Hi-Fi Products
Service Bulletin

Model: D-303

No. 237

Subject: Unit Will Not Play

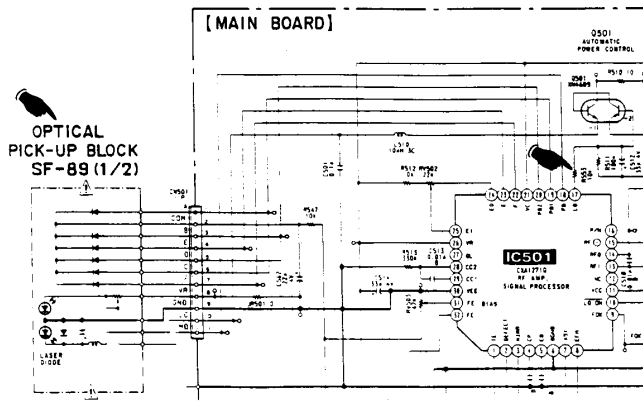
3. After performing Step 2., use green or orange magic marker and mark IC501 as shown.

- a. Label on box as shown:

- b. Green or orange mark on IC501

- Solution:**
1. Check the current into the laser diode as per instructions on page 4 of the Service Manual:
 2. If the current measured is greater than the allowed range, perform the following:
 - a. Change the optical pick-up block.
 - b. Change R553 from 10K ohms to 33K ohms.
